Figure 2.5.3(a) – Sign spacing tolerances

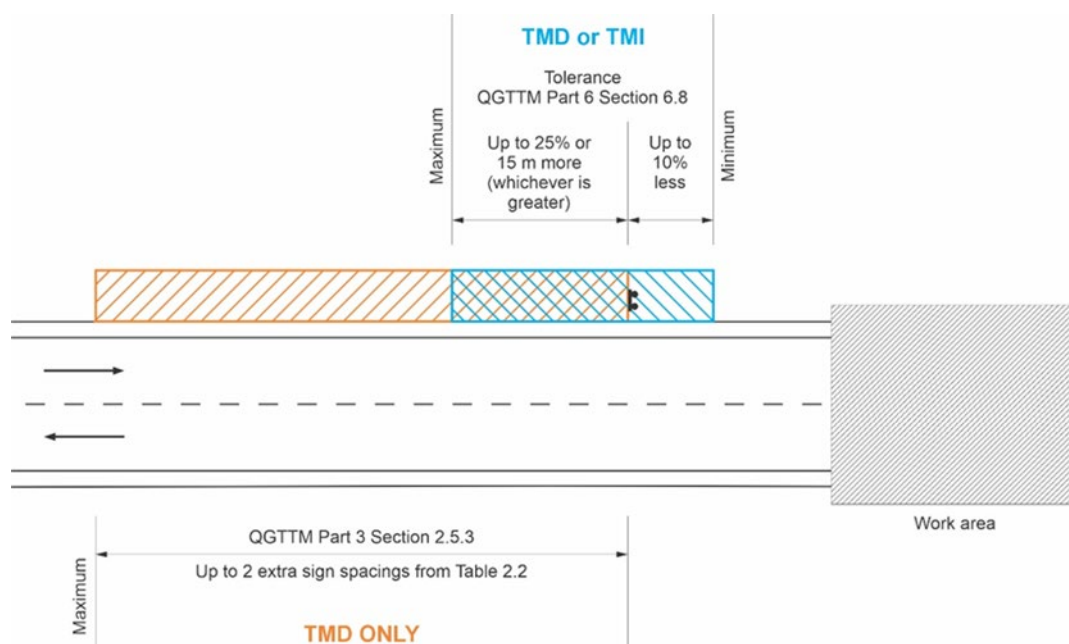
Replace:

Signs required for works which will be in progress for longer than 14 days may be installed in a more permanent manner on posts sunk into the ground. Check that underground utilities are not located below and making holes is approved by the relevant road authority. Ensure regular site inspection, maintenance and securing practices occur in these circumstances. In these situations, the installation height of all temporary signs mounted in a permanent manner must be based on the principles illustrated in AS 1742.2.

with:

While any sign may be installed in a permanent manner on posts sunk into the ground, it is recommended that signs required for works which will be in progress for longer than 14 days (that are not exclusively targeting pedestrians) should be installed in a permanent manner on posts sunk into the ground. Check that underground utilities are not located below and making holes is approved by the relevant road authority. Ensure regular site inspection, maintenance and securing practices occur in these circumstances. In these situations, the installation height of all temporary signs mounted in a permanent manner must be based on the principles illustrated in AS 1742.2 requirements in AGTTM Part 6 Section 6.6.1 and AS 1742.3 clause 4.3.2. Signs directed exclusively towards pedestrians must be installed at a height which will enable signs to be viewed easily by pedestrians (see QGTTM Part 6 Section 6.6.1).
